**Seismic Walkdown Checklist (SWC)**

Peach Bottom Atomic Power Station Unit 2  
MPR-3815, Revision 3  
Correspondence No. RS-12-173

Equipment ID: LR/TR-8123B

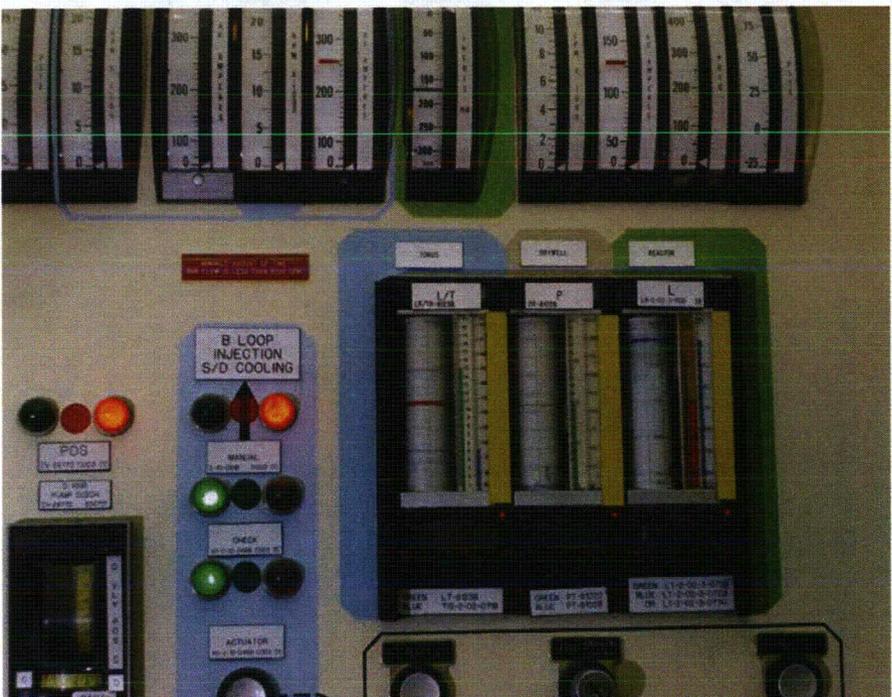
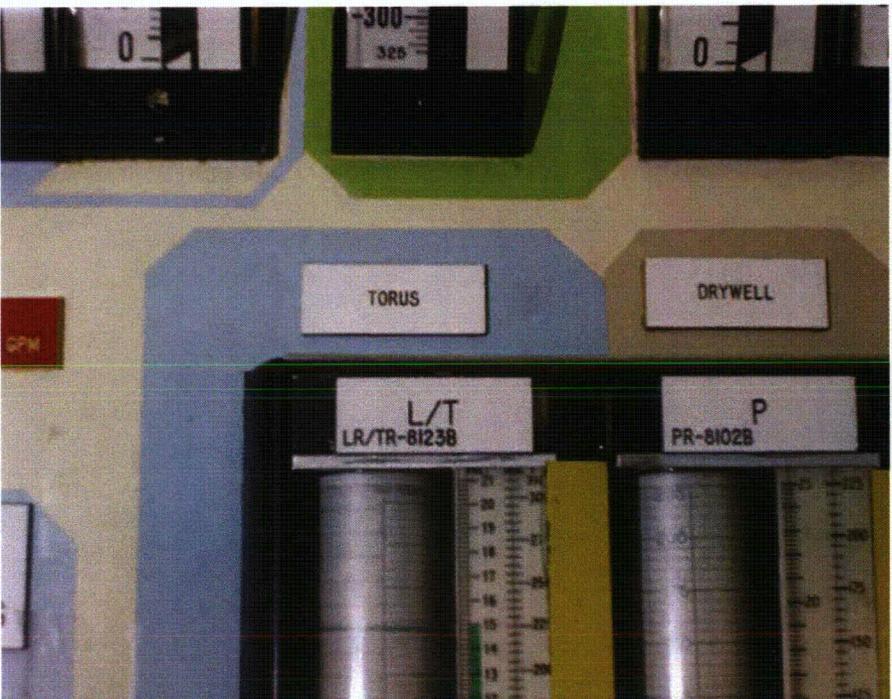
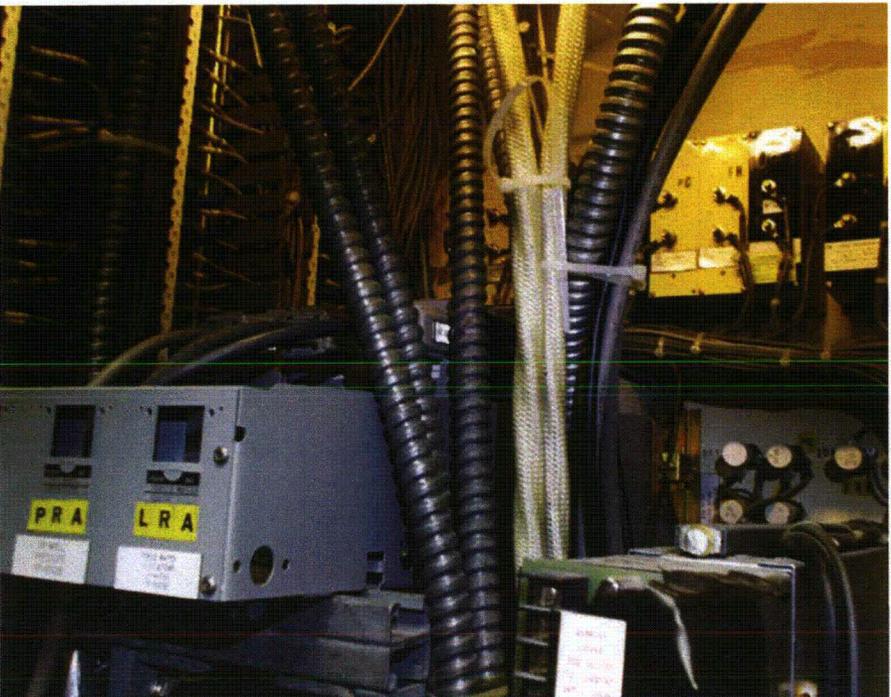
*MCR ceiling consistent with Calc 26-5/2-12, Revision 0, Calc G-106-1 could not be located. see TR 01428651.*

Equipment ID No. M02-06-029A B <sup>g/m 9/13/2012</sup> Equip. Class<sup>12</sup> (08a) Motor Operated Valves

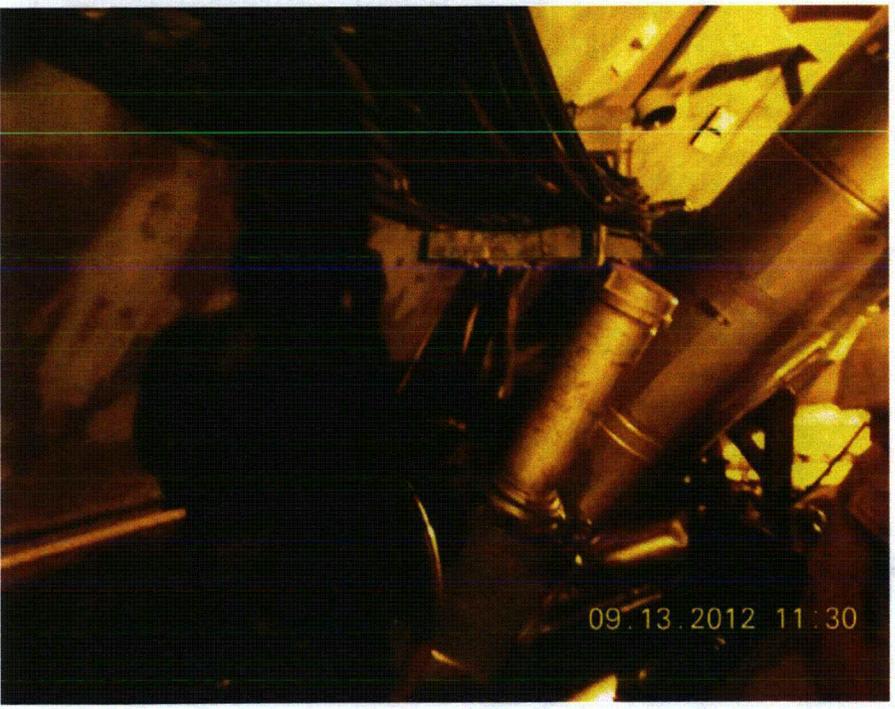
*Temporary cables attached outside of cable trays w/ zip ties judged acceptable*

Equipment ID No. M02-10-018 Equip. Class<sup>12</sup> (08a) Motor Operated Valves

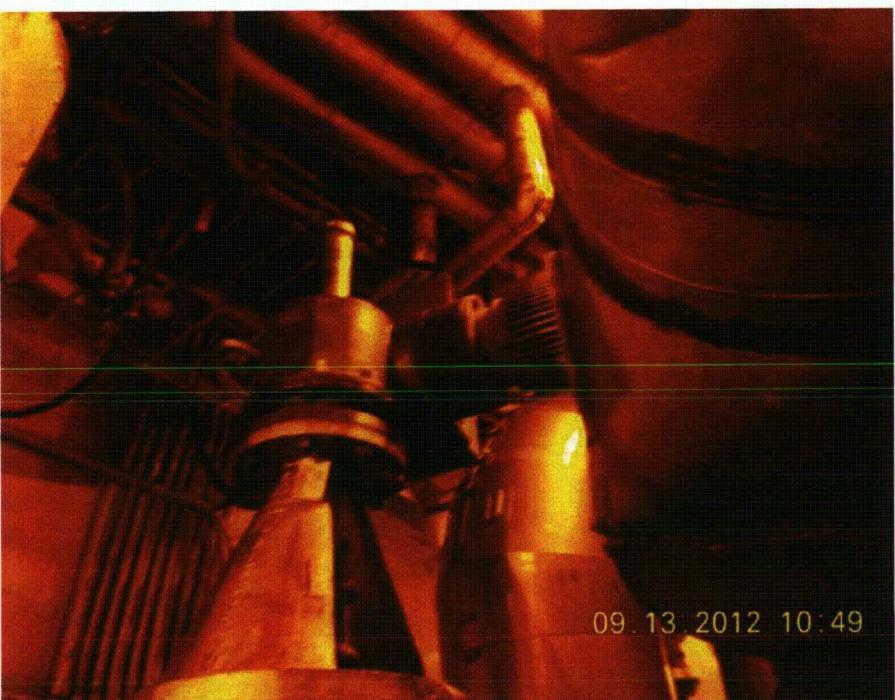
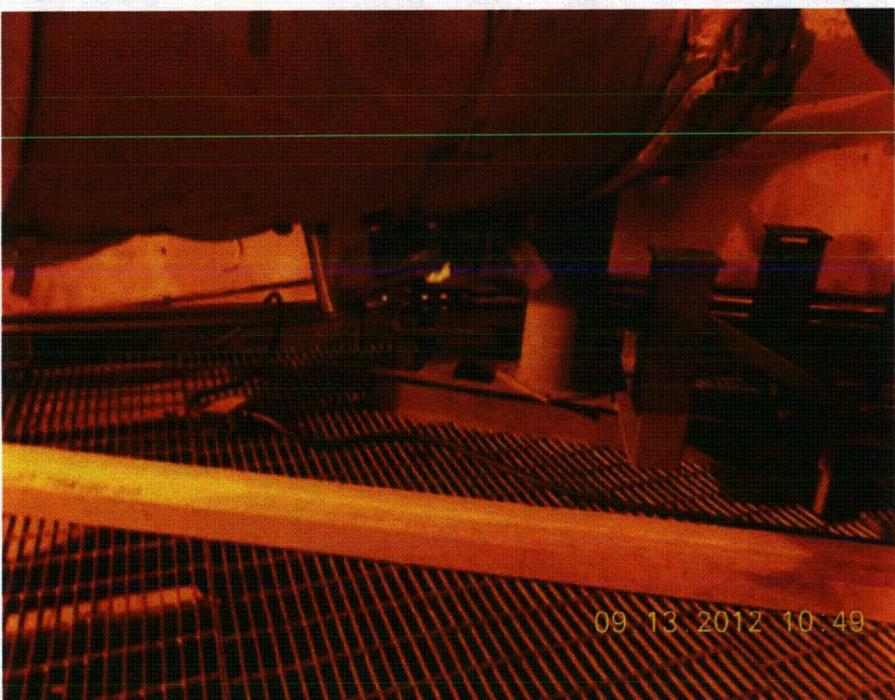
*Nearby insulated pipes have sufficient clearance*

Equipment ID: MO2-30-2233A

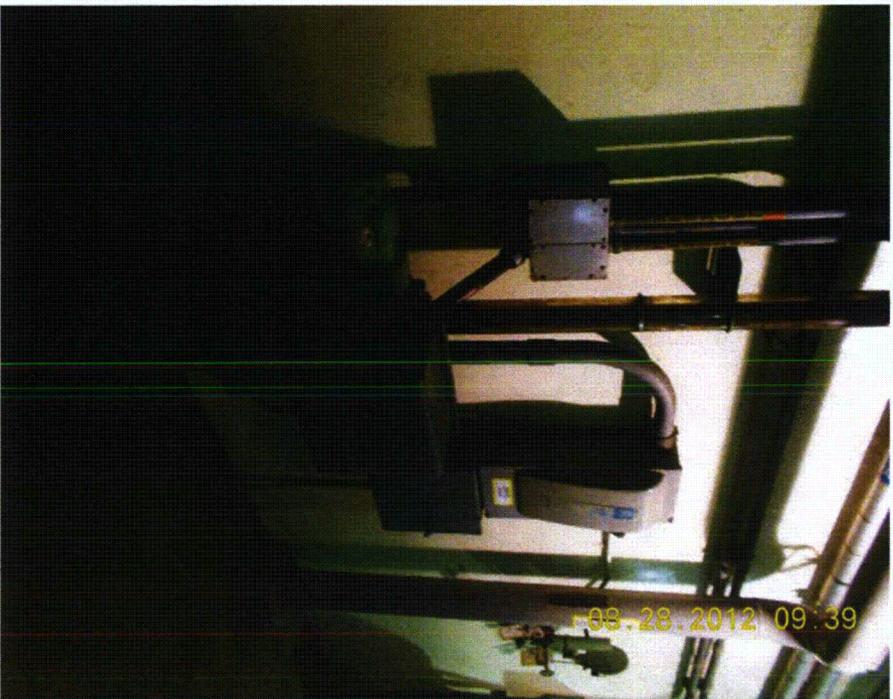
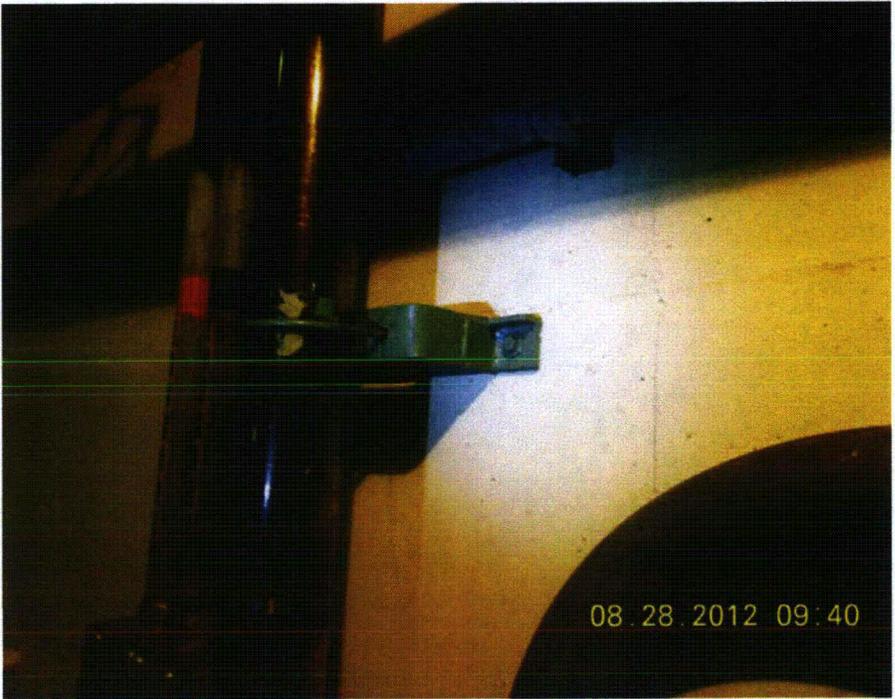
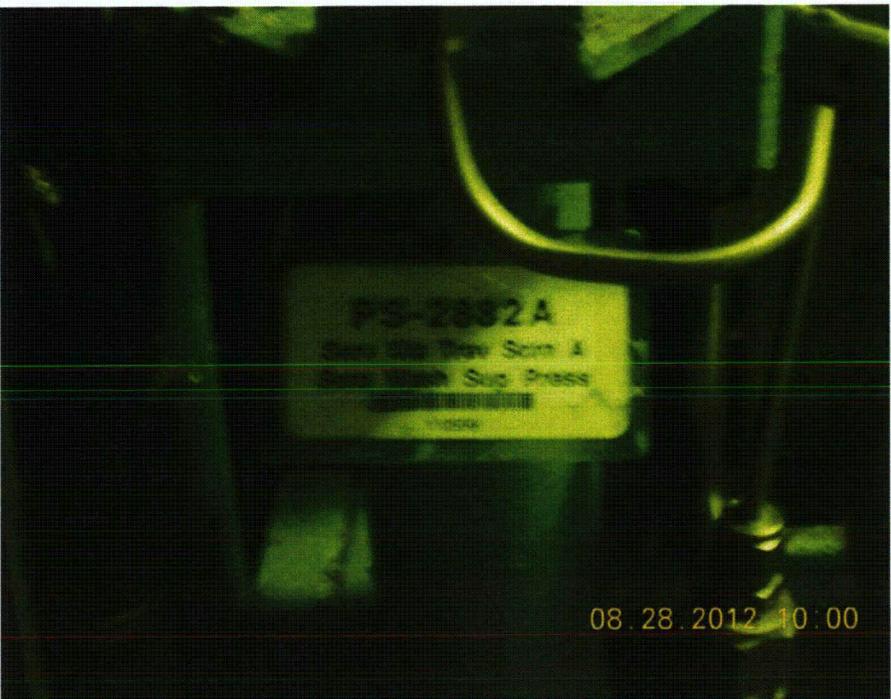
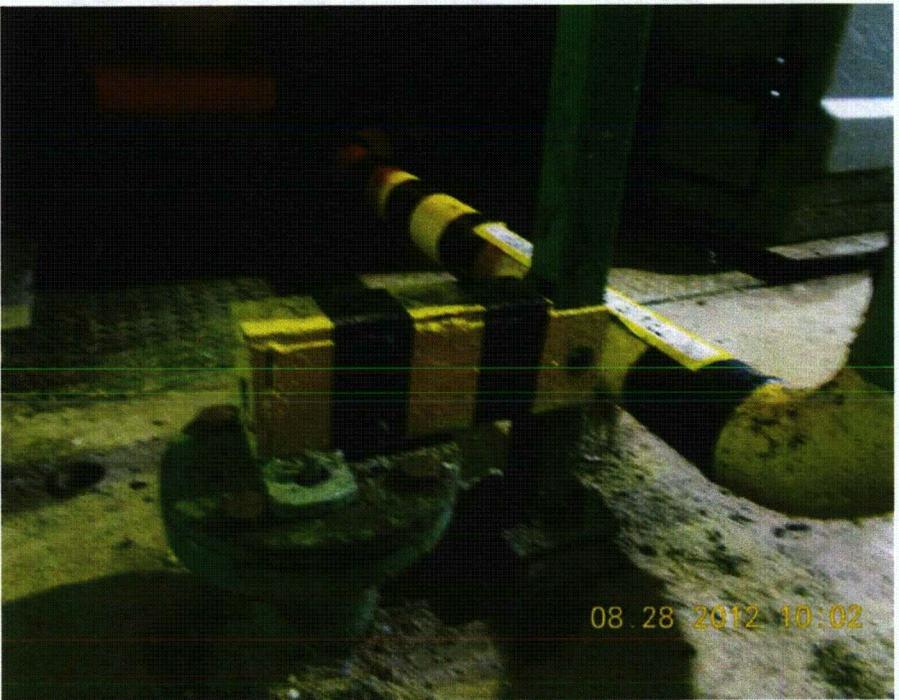
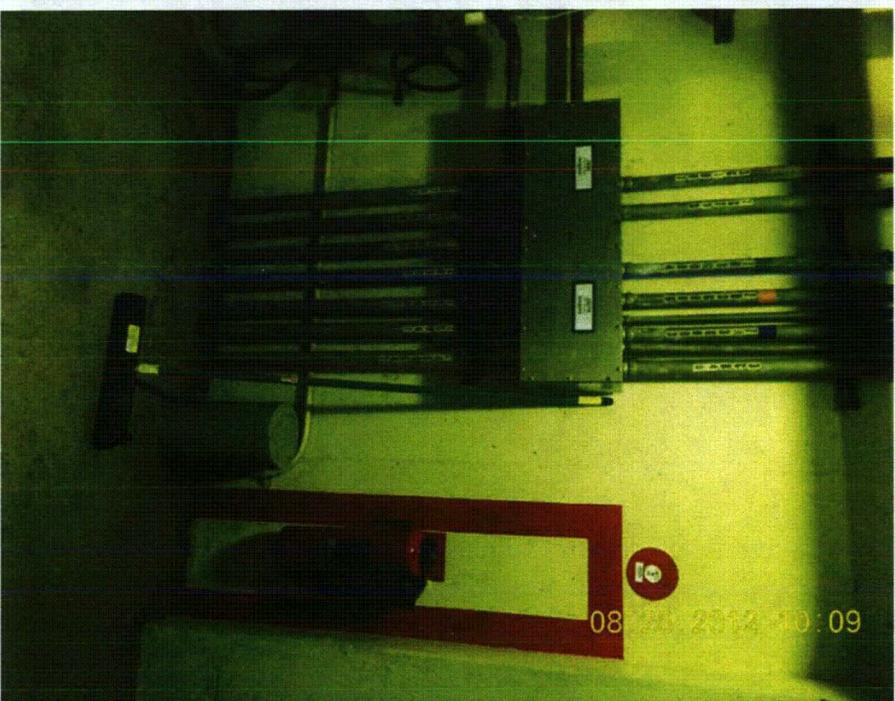
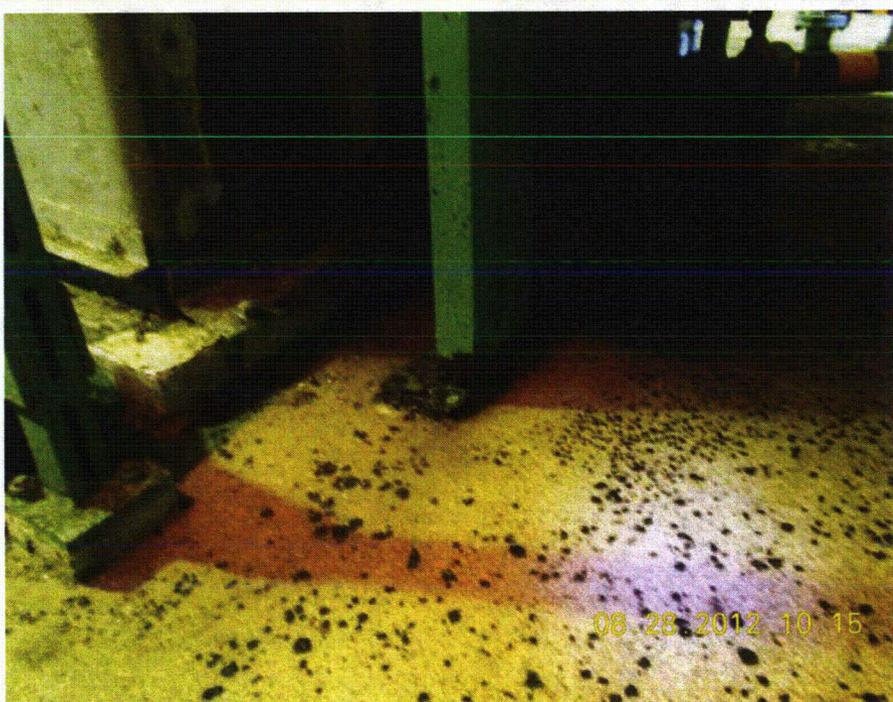
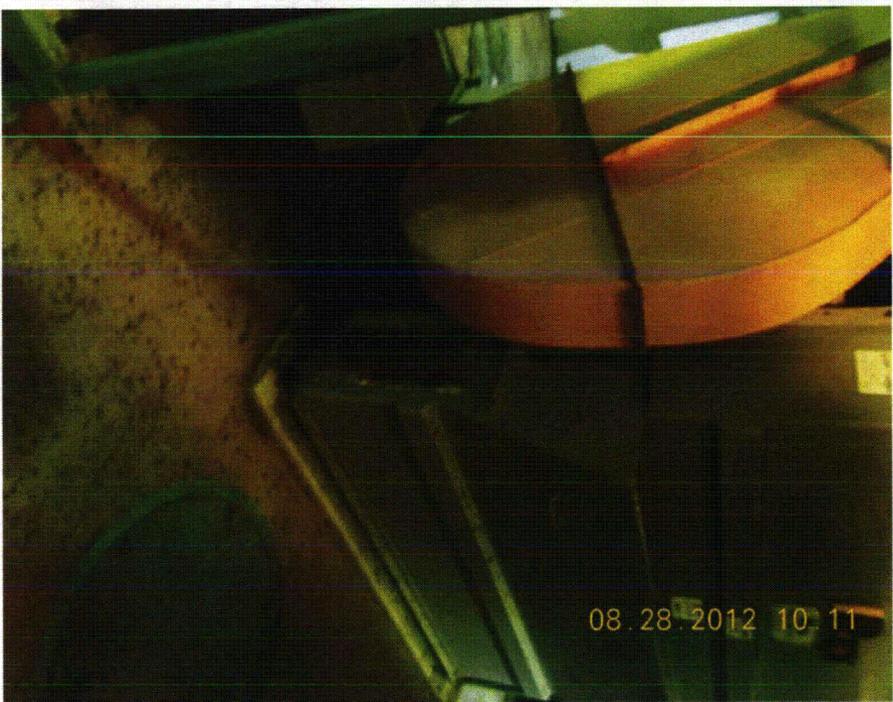
2. Is the anchorage free of bent, broken, missing or loose hardware?  Y  N  U  N/A  
*. See Comment #1*

5. Is the anchorage configuration consistent with plant documentation?  Y  N  U  N/A  
 (Note: This question only applies if the item is one of the 50% for which an anchorage configuration verification is required.)  
*. Matches Dwg. # 6280-C20-10-4 (Rev. 4)*

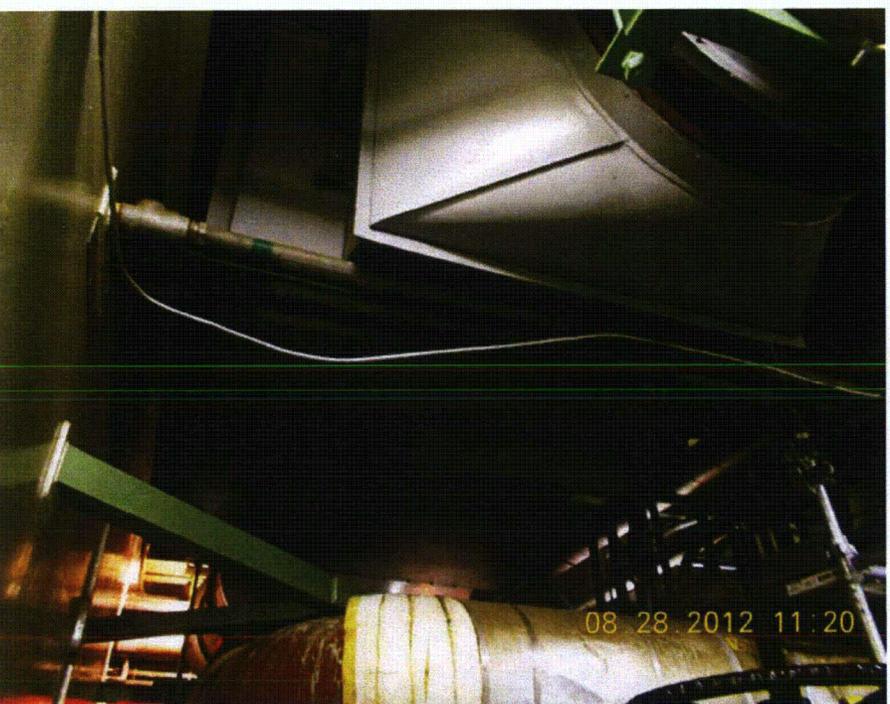
4. Is the anchorage free of visible cracks in the concrete near the anchors?  Y  N  U  N/A  
*NO POSITIVE CONNECTION BETWEEN DAMPER AND SUPPORT FRAME. BASED ON FLEXIBILITY OF TRAPEZE-STYLE SUPPORT, UNIT SUGGED TO MOVE WITH SUPPORT DURING A SEISMIC EVENT ∴ NO CONCERN.*
5. Is the anchorage configuration consistent with plant documentation?  Y  N  U  N/A  
 (Note: This question only applies if the item is one of the 50% for which an anchorage configuration verification is required.)

IPEEE: TUBING ROUTED THROUGH PROTECTIVE ENCLOSURE MOUNTED TO DAMPER SUPPORT FRAME AND IS PROTECTED FROM CONTACT WITH CONDUIT. KC 9/11/2012
